*TWDP and OMAmin comments
#38 (and others) and #35*

802.3aq, March 2006

Measured results with $TWDP > 4.7 \text{ dB}$

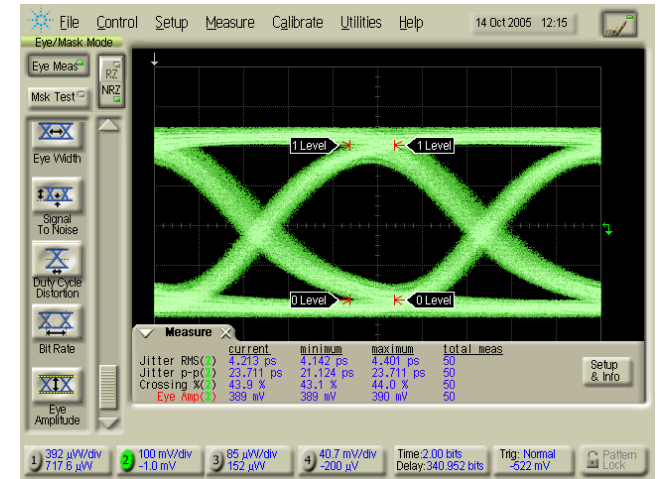
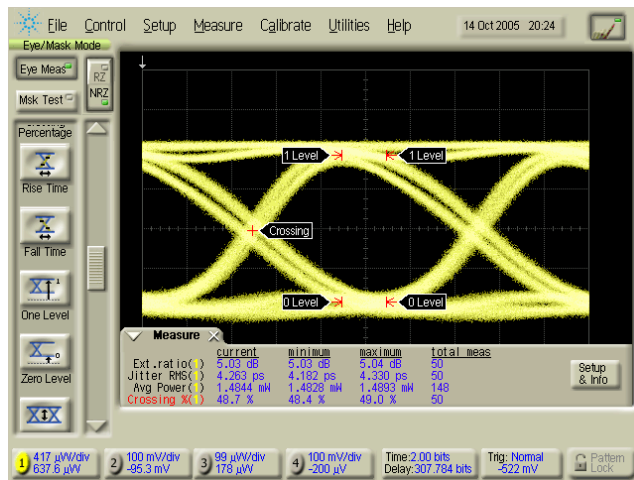
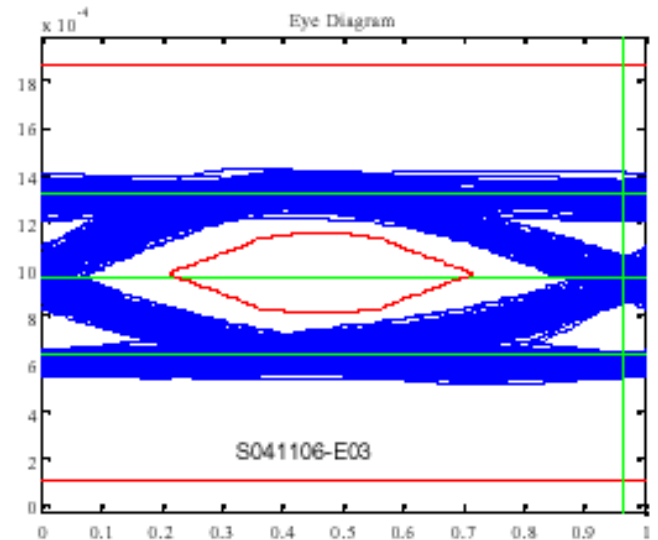
Increase the TWDP limit to 5 dB

- EDC IC technologies will continue to improve
- History has shown that lasers will not improve as quickly as IC technologies
 - Future implementations will be limited by Tx
- LRM's success will be tied to its cost
 - Relaxed Tx specs will allow lower cost in the long term

Allow lower OMA if TWDP < 4.7 dB

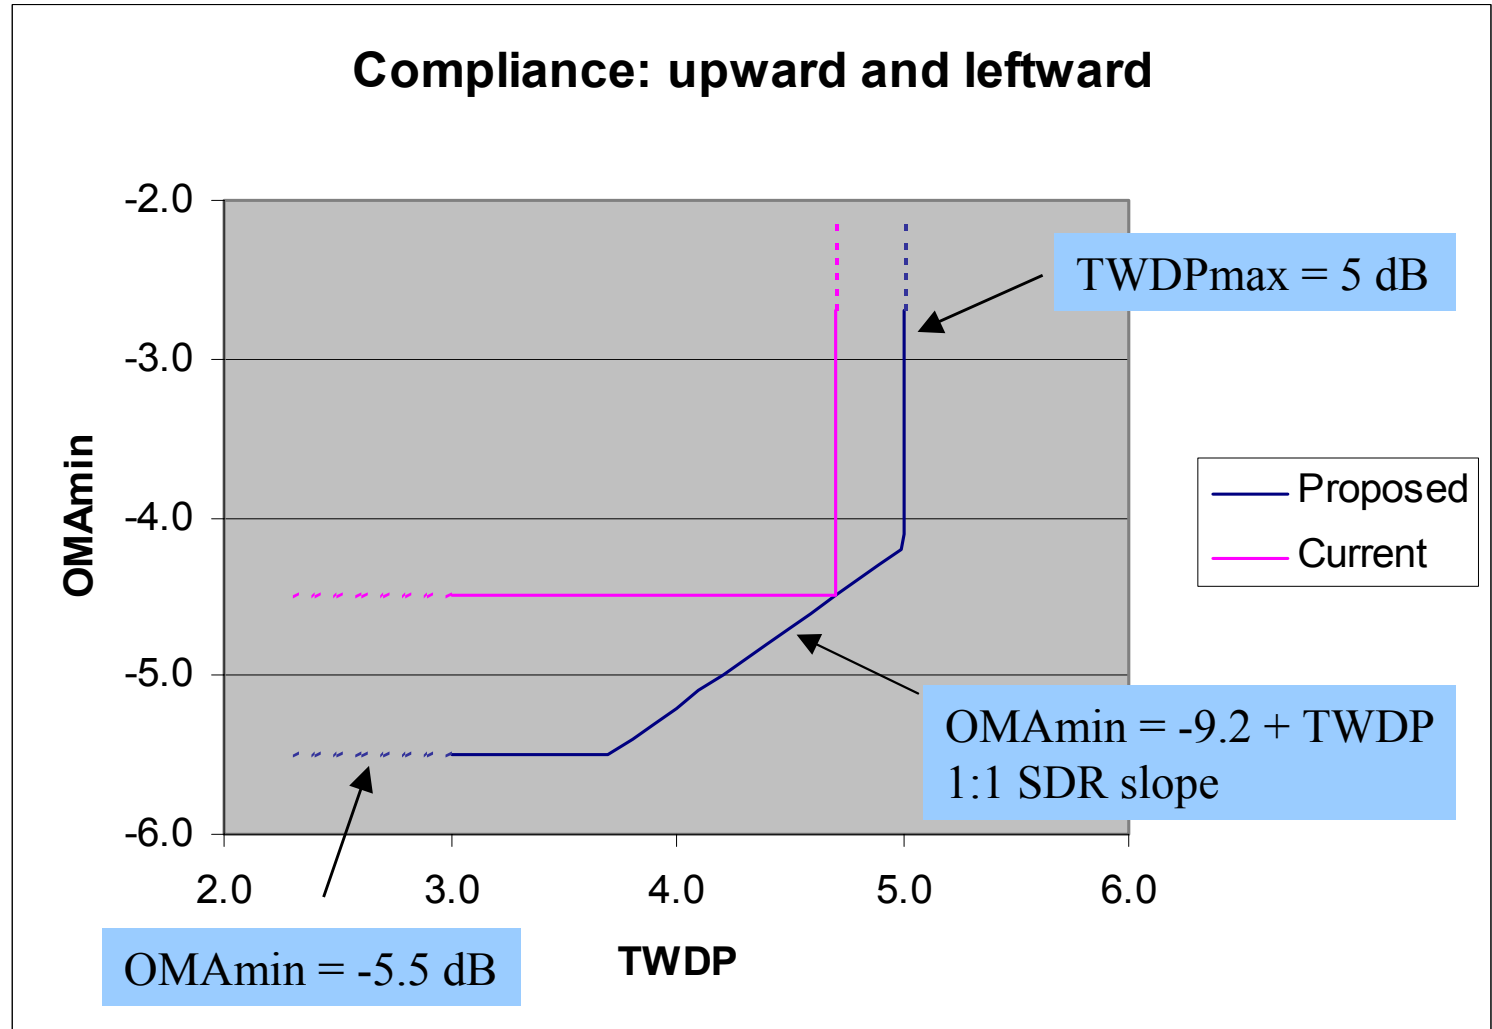
- Remedy in comment:
 - Change OMA min to -5.5 dB
 - Add new line: OMA min = $-9.2 + \text{TWDP}$
- *Intended* remedy:
 - OMA min = $\max(-5.5, -9.2 + \text{TWDP})$
- Benefits/rationale
 - Help enable 1300 nm VCSELs
 - Lower power consumption
 - Lower EMI
 - Note – P_{avg} min not affected (still -6.5 dBm)

TWDP vs. DDJ

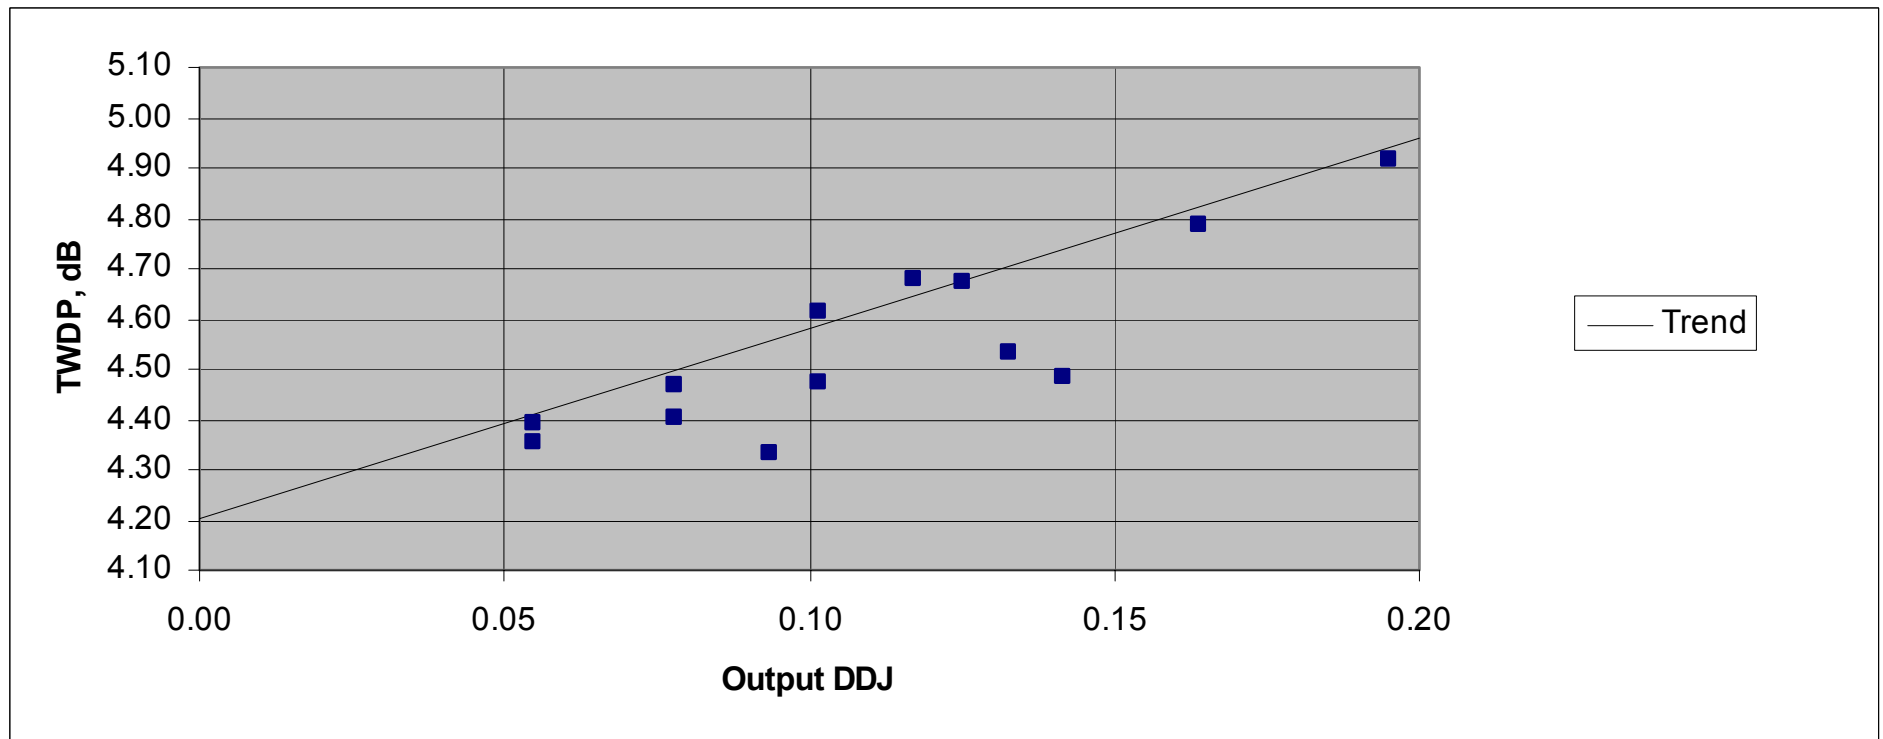
- Based on 47.1 psec Gaussian Tx
